D.T3.1.2 Deliverable title: The investment preparation documentation for pilot action in Chorzów

D.T3.1.2

Version 1
03 2020

IV. In terms of the concept of a green yard - Armii Krajowej Street

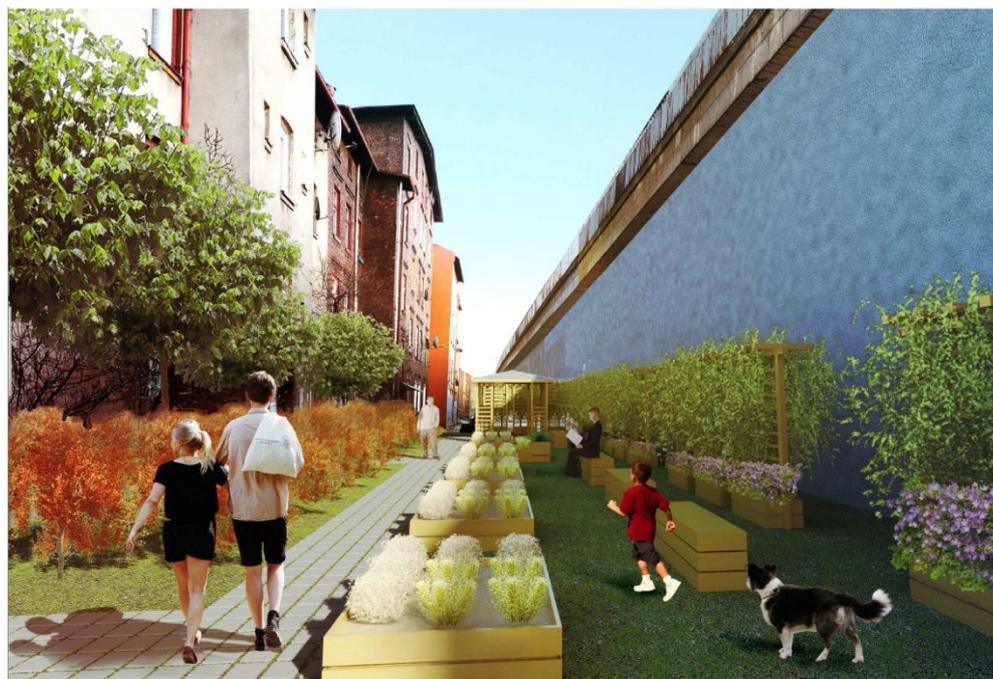
As in the case of the other three concepts, it is necessary to adapt the type of materials to financial resources intended for the investment. Therefore, we propose to limit the number of elements of small architecture presented in the concept to the necessary minimum. Leave one pot for growing herbs and wooden seats. Do not use flower pots with pergolas. Instead, plant hedge shrubs in the ground in line, at a

suitable distance from the retaining wall. The design should also include concrete pavement surfaces with grass joints and a playground for games proposed in the concept. The installation of a lawn should also be considered.

On 29.01.2020 City of Chorzów finally accepted the submitted ideas including our comments. The contractor did not include absorbent basin in the final concept for "green street". We agreed to omit the absorbent basin in the final version of the concept because they were presented by the FRANTA & FRANTA ARCHITEKCI as a proposal for possible application. FRANTA & FRANTA ARCHITEKCI also agreed to use the 'green wall' solution proposed by the City of Chorzów taking into account reduction by a 0.5 m module on each side.
